GYPSY WINCH NO 3
STATION 5
MASTER CONTROL
57115250A

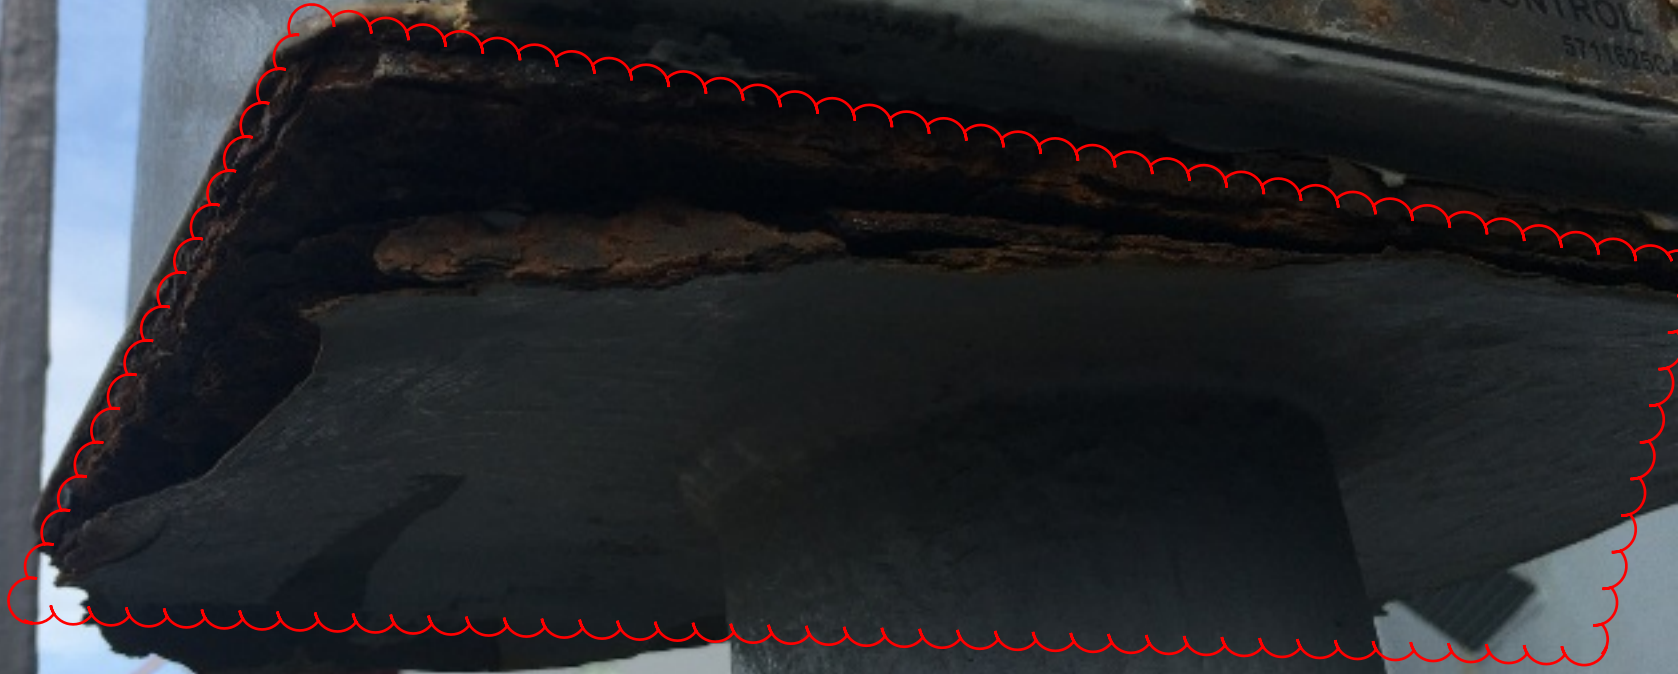
REMOVE AND REPLACE FAILED PLATE ON
CONTROLLER STAND. PLATE SHALL BE MADE
FROM STAINLESS STEEL, 9" x 13.5"

Base can be removed if required to complete work item.
